Interactive comment on “Reliability of water distribution networks due to pumps failure: comparison of VSP and SSP application” by N. Mehzad et al.

Responses of the authors to the reviewers’ comments on the paper entitled “Reliability of water distribution networks due to pumps failure: comparison of VSP and SSP application” By N. Mehzad, M. Tabesh, S. S. Hashemi, and B. Atae Kia

Fig. 1. The comparison of reliability of two type of pumps (VSP, SSP), with weighted average of four scenarios using three nodal pressure equations.

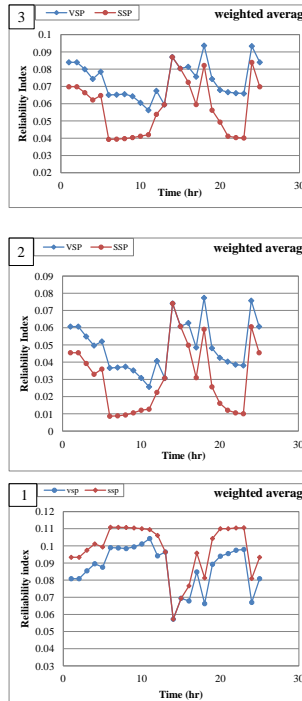
Appendix: figures in page 372 should be replaced by these figures.
